SERVICE BULLETIN

BULLETIN NO: 14-010

TITLE: Field Service Bulletin for TURCK M12 Coupling Nuts and Valve Plugs

PRODUCT SERIES / MODEL: All M12 Coupling Nuts and Valve Plugs

FIGURE 1
LABEL DETAIL

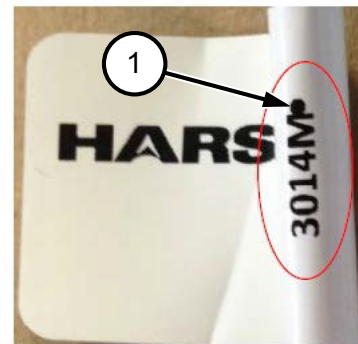
As a means to track the design change, TURCK implemented a special marking, a small dot adjacent to the TURCK Date Code, on the labels. All products bearing this special marking are the newly designed products. An example of the special marking, dot applied next to the date code, is shown in this Service Bulletin.

- (1) Dot Marking Next to TURCK Date Code
- (2) Harsco Rail Part Number
- (3) Ø15.0 mm Anti-Vibration Coupling Nut
- (4) Ø13.5 mm Coupling Nut - Identify and Return to TURCK for Replacement
- (5) Old Style Valve Plug with Visible LED
- (6) New Style Over Molded Valve Plug

FIGURE 2
CABLE DETAIL

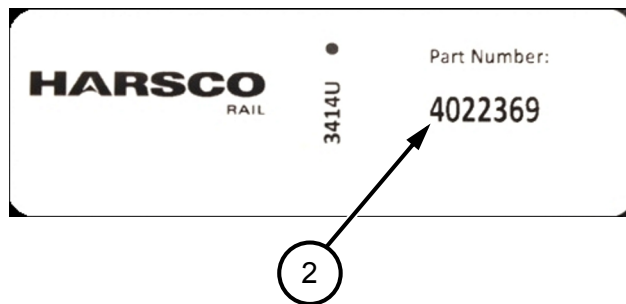
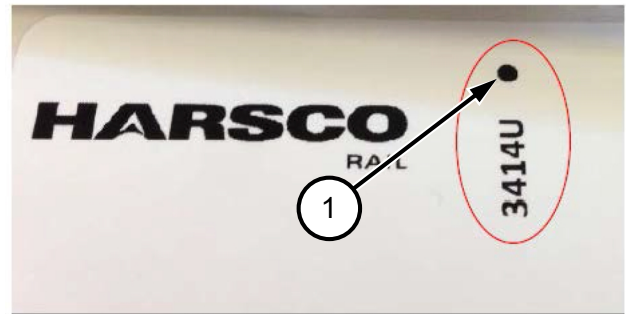
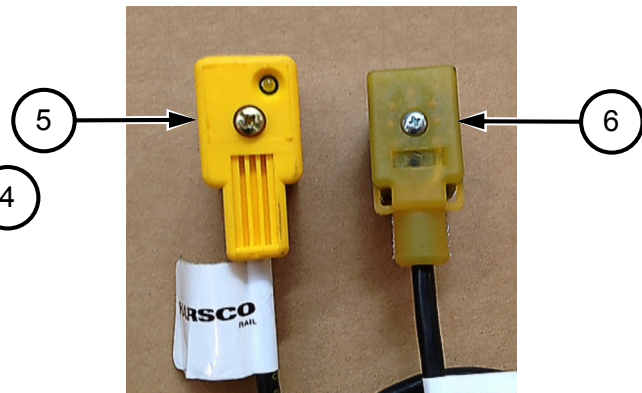
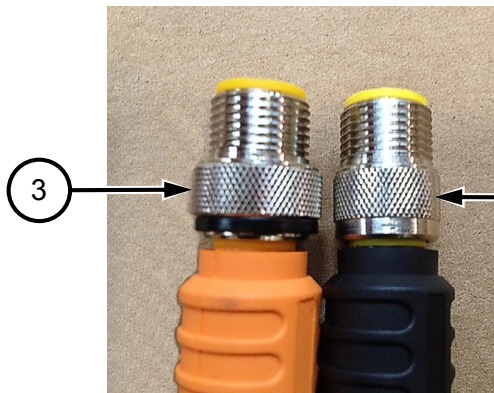
SUMMARY: **Ø13.5 mm versus Ø15.0 mm M12 Coupling Nuts:** As a continuous improvement TURCK generated an Engineering Change Order that changed the coupling nuts from a non anti-vibration coupling nut having a 13.5 mm outer diameter across the knurling to an anti-vibration coupling nut with a 15.0 mm outer diameter across the knurling. At the time of the change, not all TURCK products were part of the Engineering Change Order. Due to this, TURCK continued to manufacture a select number of finished assemblies having a coupling nut with a 13.5 mm outer diameter of across the knurling. TURCK has generated a Return Material Authorization (RMA) Number 43820. This number is to be used to return products in stock which have the 13.5 mm outer diameter across the knurling. This RMA number is valid through December 31, 2014. A copy of RMA Number 43820 is located on the last page of this Service Bulletin.

There exists a risk of LED component failure or weak light caused by the original Valve Plug design change. Internal PCB cracking during the epoxy filler curing process, which causes an operational fault failure between the PCB resistor and LED.

1. Inspect your stock of Harsco Rail supplied cable assemblies with M12 connectors (sourced from TURCK). Determine if the cables have the 13.5 mm diameter coupling nut. Determine if the cable assembly with the M12 Male connector and the Valve Plug connector, new style, does not have a small dot marking near the TURCK Date Code. *Note: The cable end molding may be black, yellow or orange.*
2. If either cable issue is found, return the cables directly to the TURCK for replacement.
